Peterborough Residents Group Inc.
19 Macs Street, Peterborough Vic 3270
ABN 52 658 1739 39
CAV Registration A0045787 R

30th August 2024

This submission is made on behalf of the Peterborough Residents Group (PRG) following the review of the town planning application and its supporting documents. The PRG considers that the proposal DOES NOT provide a positive design response to the site and surrounds and DOES NOT adequately address all provisions of the Planning Scheme.

Figure 4 Location of landscape drainage features in Peterborough (extract from Residential Design Guidelines 2006)

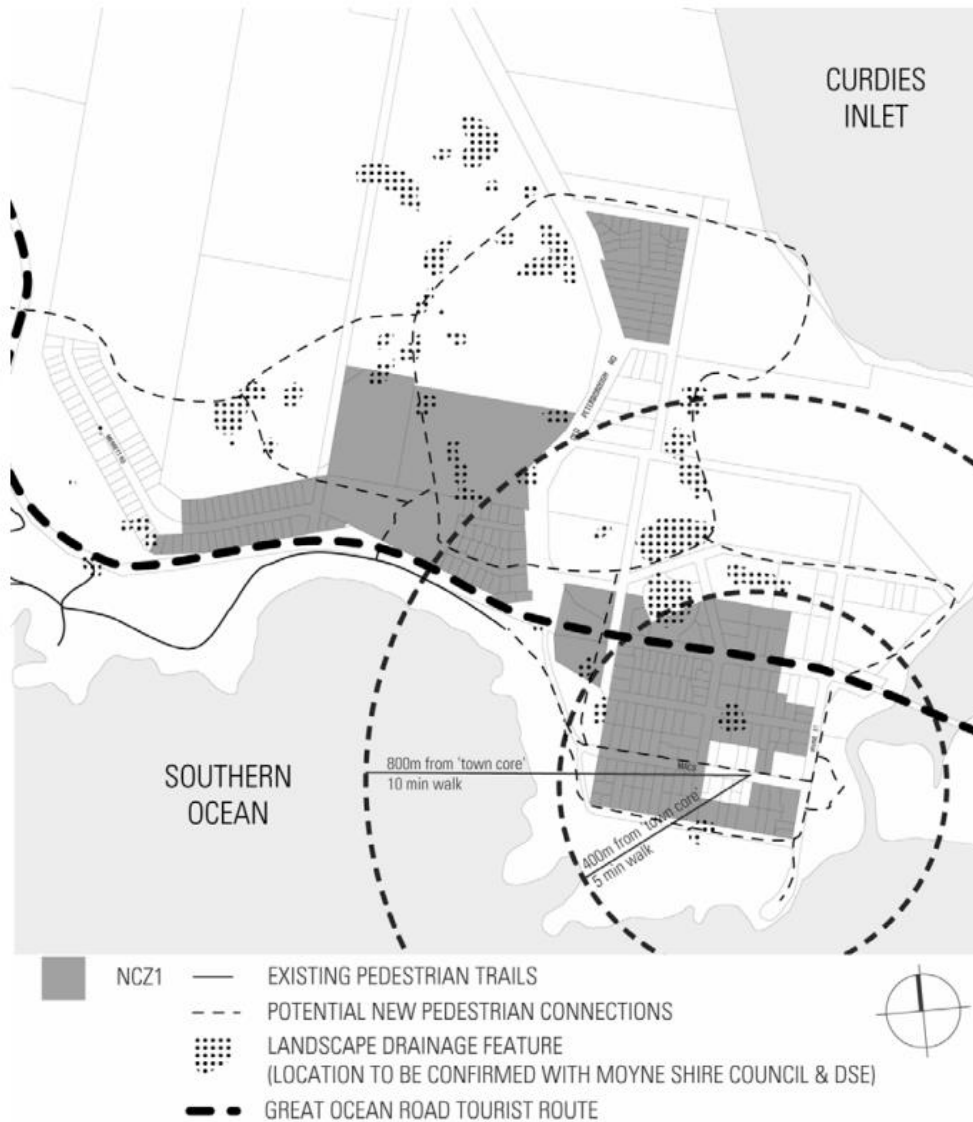
7. Figure 4 depict the location of 'sinkholes' in the subdivision area. The location of the Reserves is inconsistent with the natural depressions/sinkholes in the subdivision area. The Reserves should align with the natural de to maintain the

ecological integrity, including the groundwater dependent ecosystems that are dependent on the sinkholes.

Figure 5 Location of limestone sinkhole (extract from Residential Design Guidelines 2006)

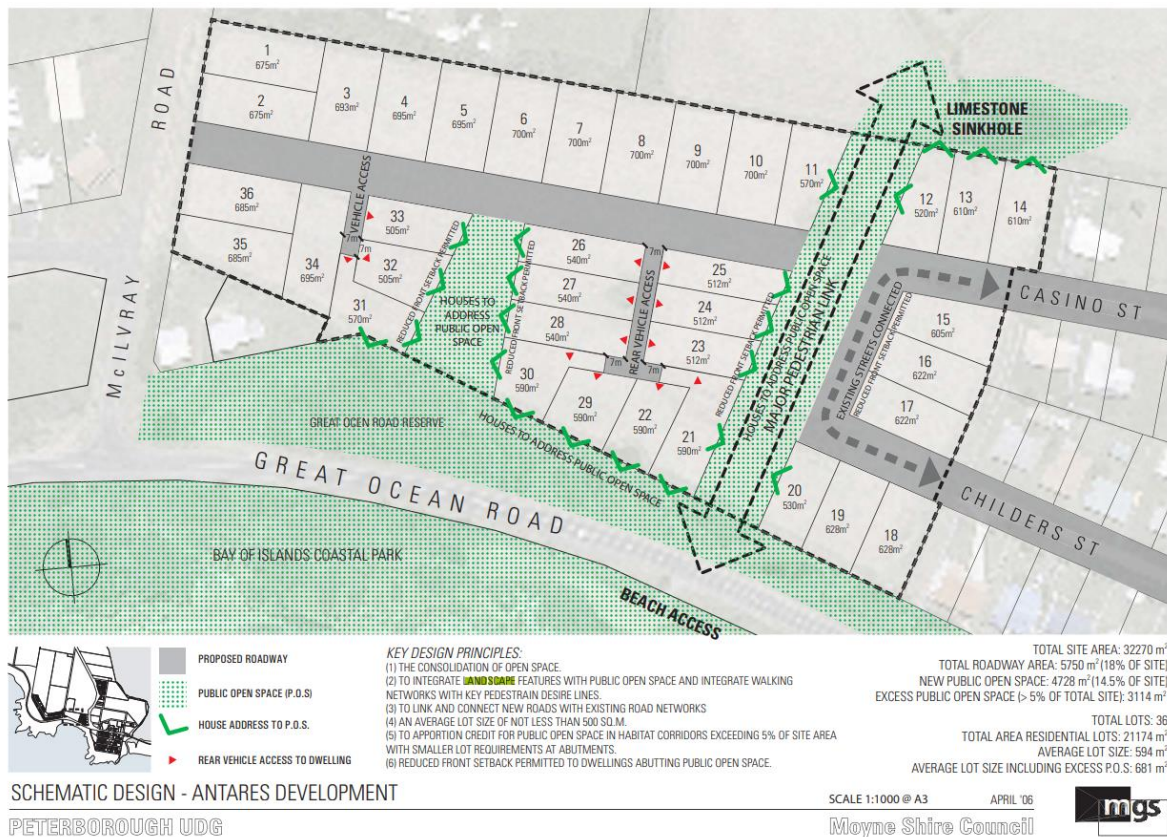
8. Residential Design Guidelines, Peterborough, Victoria (May 2006) depicts a Limestone Sinkhole directly north of Antares Estate. This has not been considered in the 58-lot subdivision.
